**MINUTES OF MEETING – Construction Reference Group (CRG)
Murdoch Drive Connection
Meeting #6**

Date:	Monday 6 th August 2018	Time:	18:00-20:00	Location:	Metropolitan Road Improvement Alliance
Distribution:	All CRG members and meeting visitors

2031 With Noise Mitigation

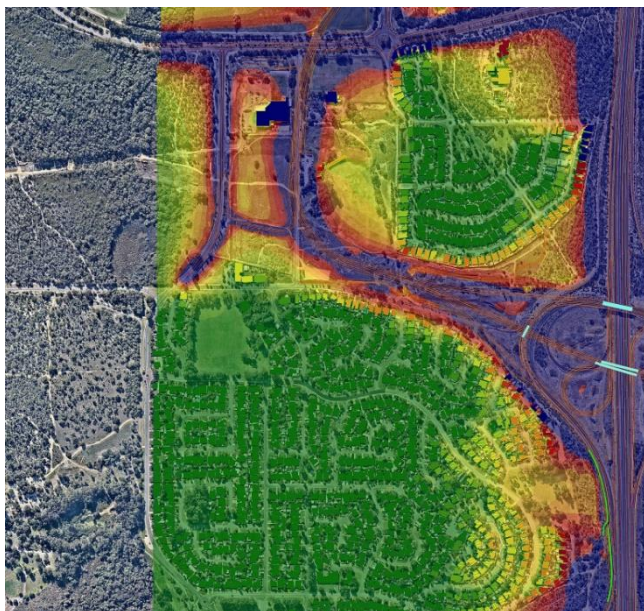
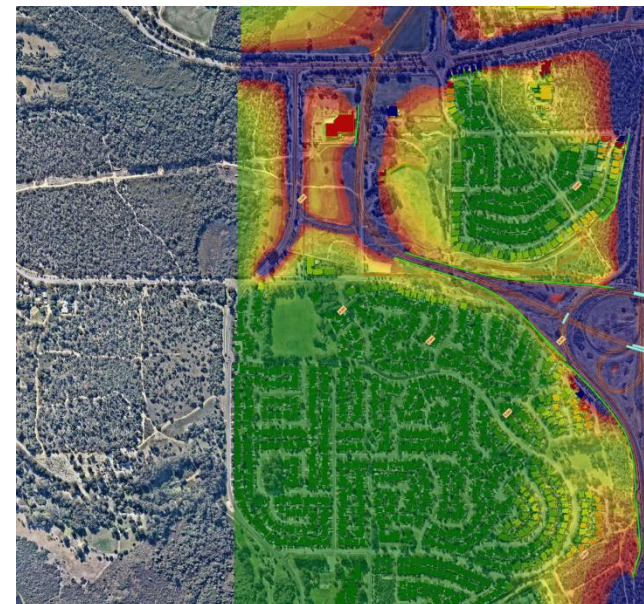
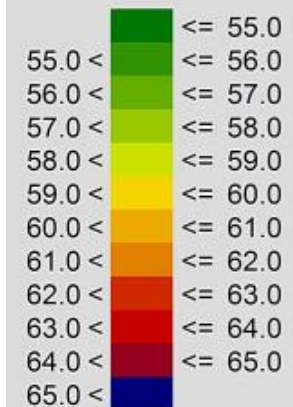
- Existing noise walls are considered in the modelling
- The 2031 with noise mitigation diagram doesn't show the return walls at Murdoch Chase (subject to environmental approval). The walls would be 5m off the boundary and 4m high.

- Existing noise walls in the south western quadrant will be replaced with taller walls.
- The Lakeside site is shown in red and noise levels exceed permitted levels with mitigation required.

2021 – 5m High Wall Adjacent to the PSP

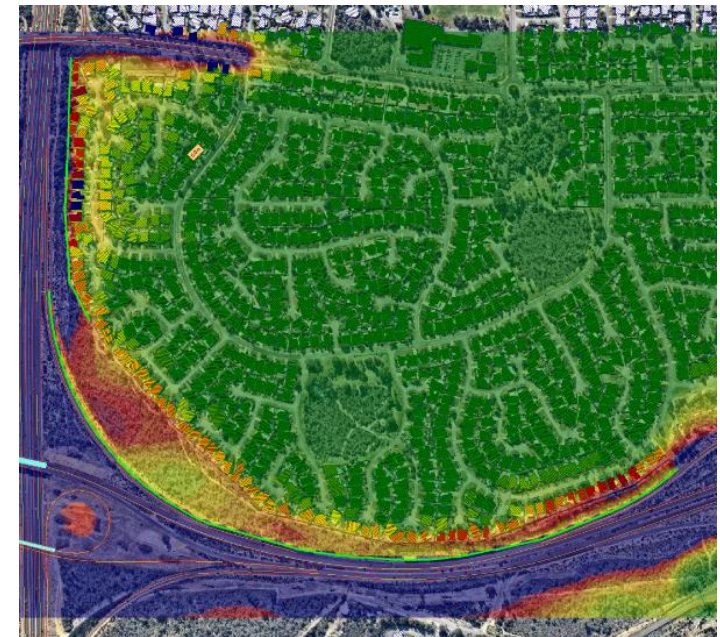
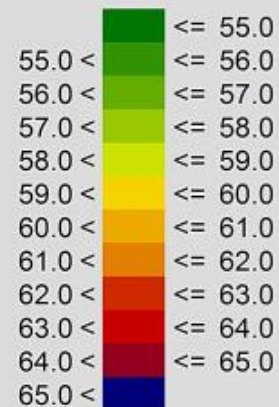
- Previously proposed noise wall on boundary, 2.4 metres
- Opportunity identified to move the wall closer to the source
- 5 metre high noise wall on the edge of PSP recommended
 - Lower impact to local residents
 - Maintains access to bushland
 - Positive noise mitigation results
 - Lower environmental impact

NO.	ITEM / DETAILS
Q	How does 2.4m wall on the property boundary compare to the off boundary location?
A	<p>Both options offer similar overall noise mitigation results, with some variation for individual properties. Both options are also similar in cost. The difference that guides the recommendation is lower environmental, property and construction impacts associated with the off-boundary location.</p> <p>We do value the opinions of directly affected residents and will be discussing with individual property owners.</p> <p>Jorelle to liaise with Leeming resident (anonymous) to arrange a follow up meeting to discuss the recommended option and consultation approach.</p> <p style="text-align: right;">ACTION: Jorelle</p>
Q	Could a hybrid solution of on and off boundary options result?
A	No, as it is less effective, impractical and hard to achieve.
Q	Felicity noted that this area of land is an offset from Roe7 project and would require further offset if affected.
